ADMINISTRATIVE SITE PLAN APPROVAL - SOPER HILL TOWNHOMES

PROJECT INFORMATION										
Project Title	Soper Hill Townhomes Da		ite of Report		October 29, 2021					
File Number	PA21-025 At		tachment	Site plan (Exhib MDNS (Exhibit			oit 29) and SEPA 33)			
Administrative Recommendation	Approve the townhouse site plan subject to the conditions of approval contained in Section 2.0.									
BACKGROUND SUMMARY										
Owner/Applicant	CPD Marysvi	CPD Marysville, LLC								
Request		Administrative site plan approval in order to construct a 49-unit townhouse project consisting of seven buildings and associated site improvements.								
SEPA Status	A SEPA MDNS was issued on September 24, 2021. The appeal period expired October 11, 2021; no appeals were filed.									
Site Address	8609 Soper Hill Road		<b>APN</b> (s)	0059	0590700031700					
Legal Description (abbreviated)	See site plan for legal description		Section	01	Township	29	Range	05		
Comprehensive Plan	MU-WR	MU-WR Zoning MU-WR Sh			Shorelin	reline Environment			N/A

**A-1**

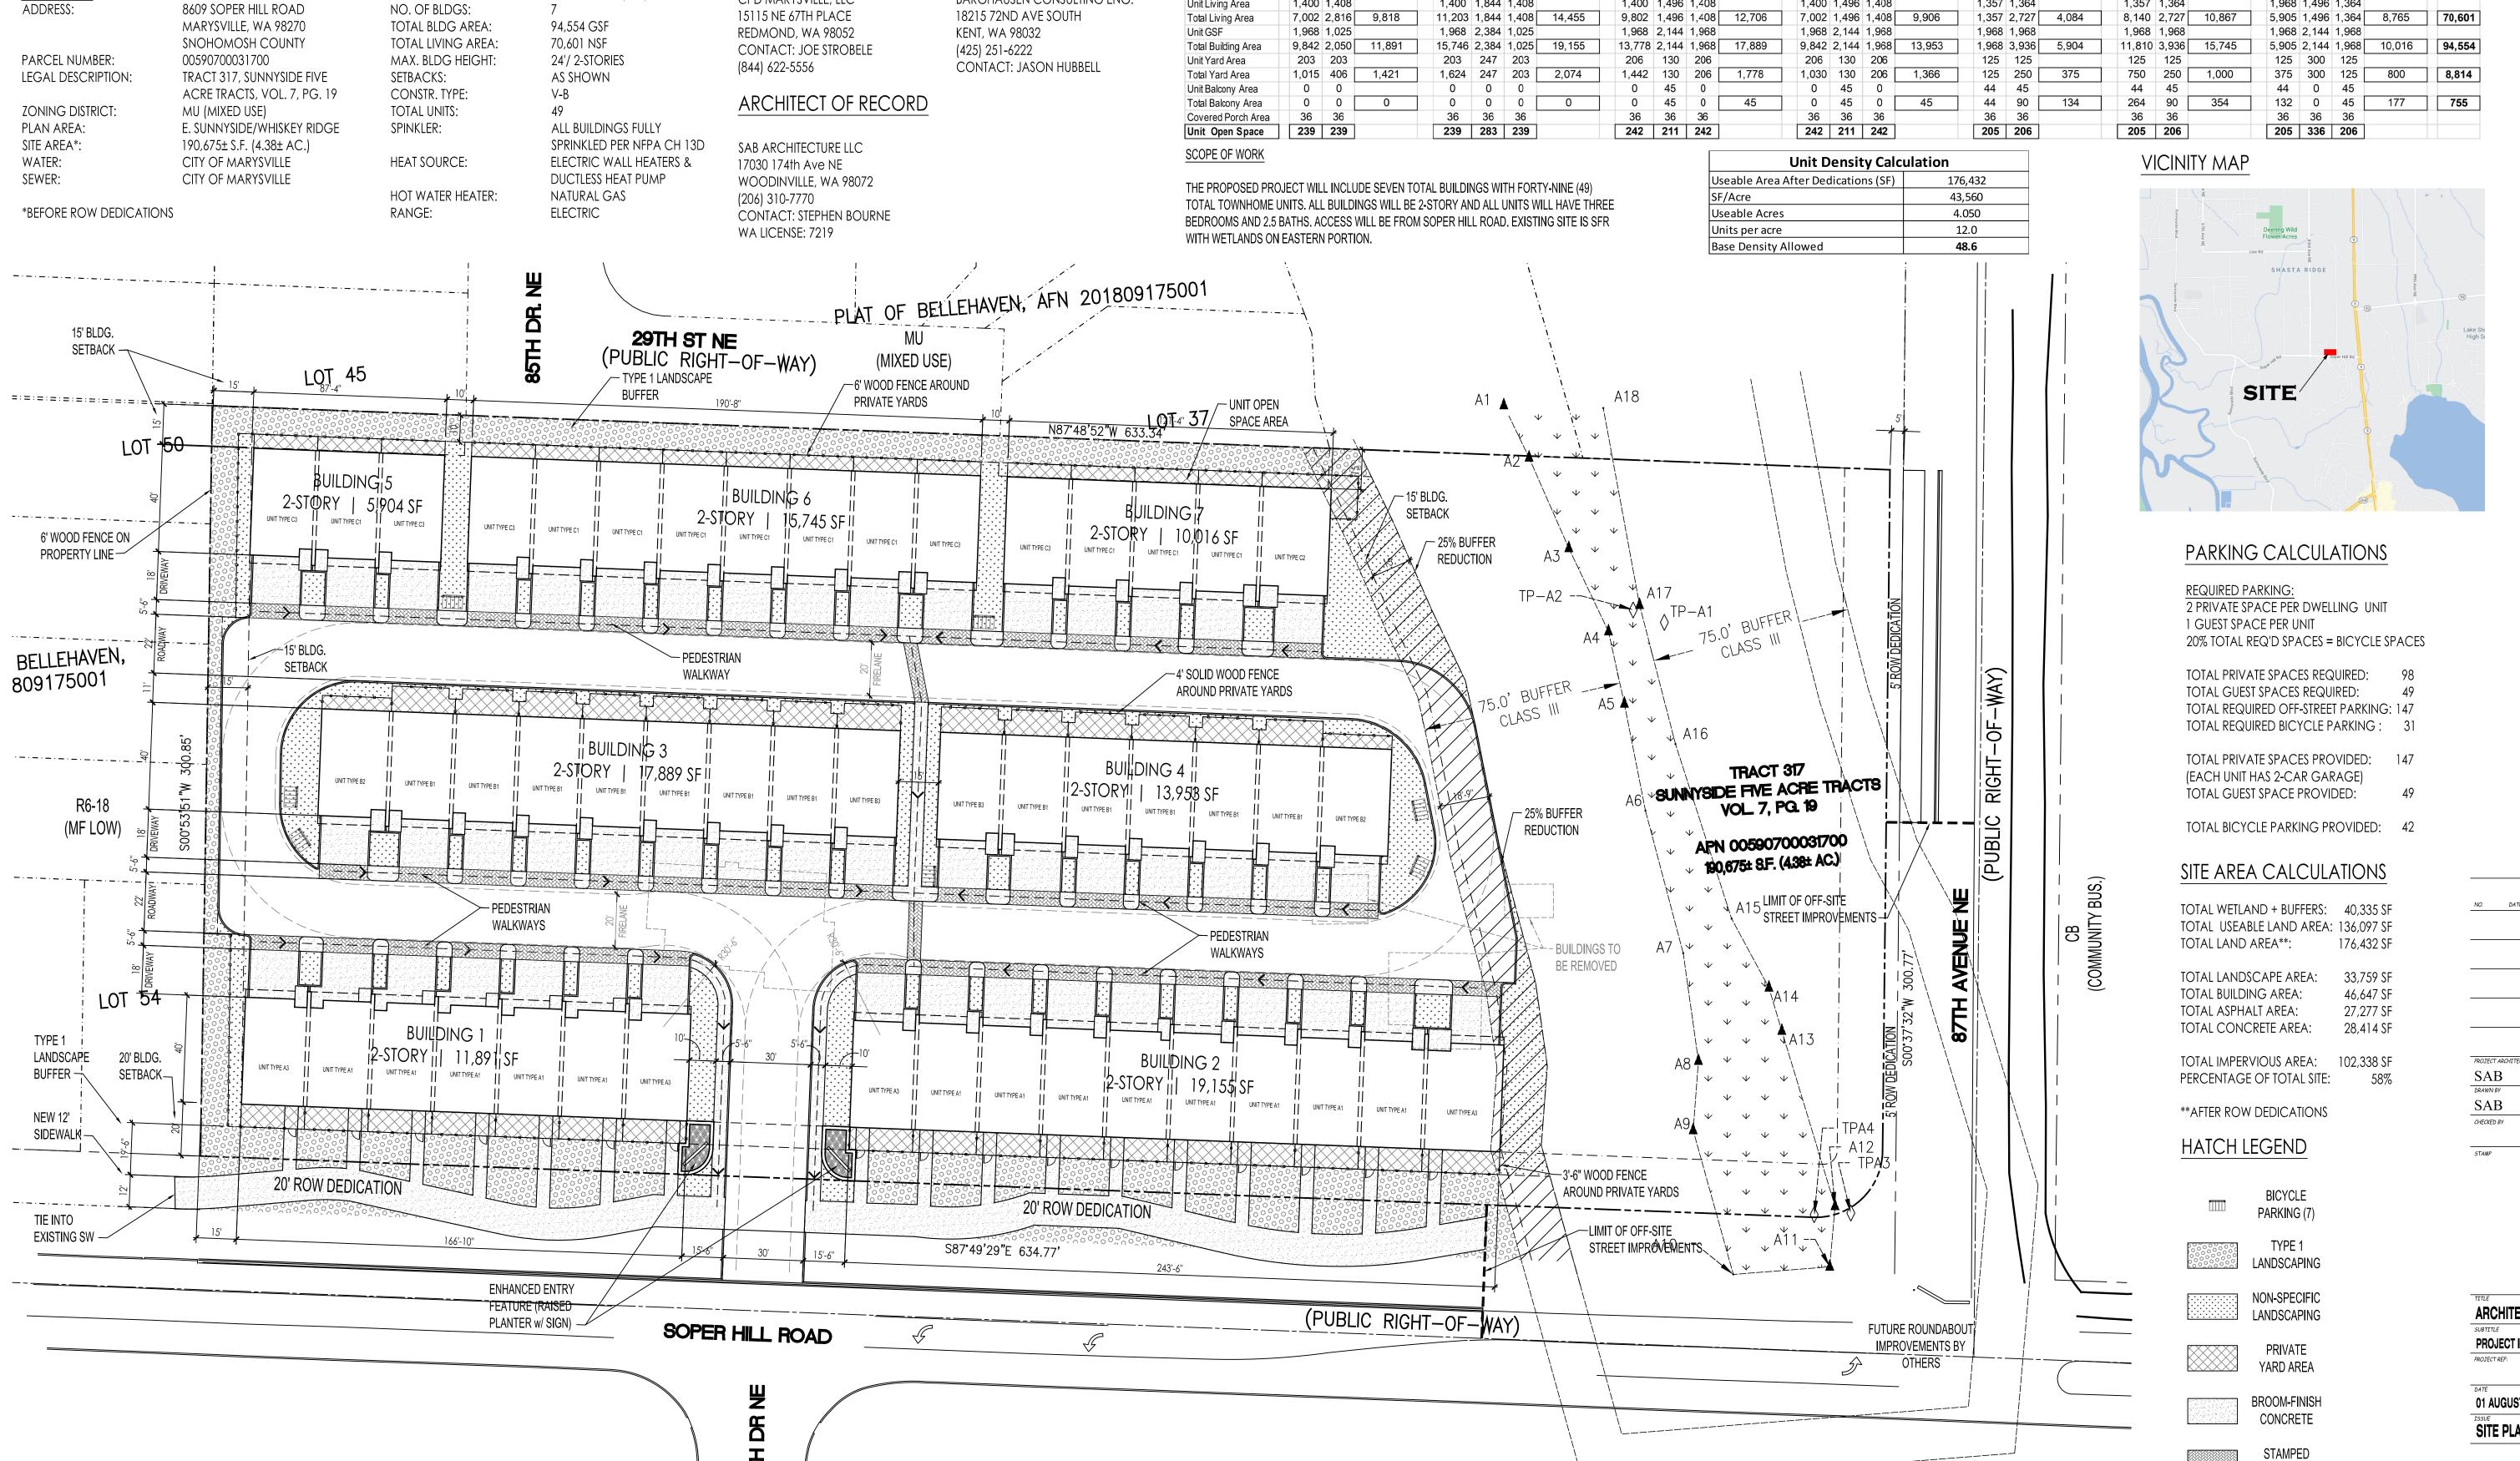
- The civil plans indicate a 20-foot-wide dedication to the Soper Hill Road ROW and the proposed frontage improvements include a 12-foot-wide sidewalk with retention of the existing ditch and curb/gutter. Frontage improvements along Soper Hill Road shall be as per the Soper Hill Road ILA executed between the City of Marysville and the City of Lake Stevens. This calls for two eleven foot travel lanes and a 12-foot-wide center turn lane, a 12-foot-wide shared use path and a road buffer accommodating variable width planters. The applicant's plans (including civil, site, and landscape) need to reflect the biofiltration swale consistently across all plan sets and maintenance of the swale shall be the responsibility of the townhome association. The City of Lake Stevens suggests that the pathway meander and tie into the recently developed ROW directly to the west for consistency.

- Please update the road sections for Soper Hill Road on the civils to match our EDDS. Please contact Erik Mangold at Lake Stevens for further clarification.

e. Marysville Fire District: In an email dated May 28, 2021, David Van Beek, Assistant Fire Marshal, indicated that there are "no serious fire concerns, may need one more hydrant where the entry road tees left and right."

Staff Response: Melissa Place, Senior Planner, with the City of Lake Stevens provided a follow-up email dated August 17, 2021 after review of the second site plan submittal. The email indicates that "it appears that all of our previous comments have been addressed in the resubmitted plans." City of Marysville and City of Lake Stevens staff will review the required road improvements further during civil construction plan and right-of-way permit submittals.

*Staff Response:* The Fire District's comments are to be addressed during civil construction plan or building permit review as applicable.

- 1. The site plan received August 2, 2021 is the approved site layout (Exhibit 29).
- 2. The applicant shall submit payment to Lake Stevens School District No. 4 for school impacts caused by the development in accordance with MMC Chapter 22D.040, School Impact Fees and Mitigation. School mitigation fees will be based on the fee schedules in effect at the time an individual building permit application is accepted by the City, and will be required to be paid prior to building permit issuance.
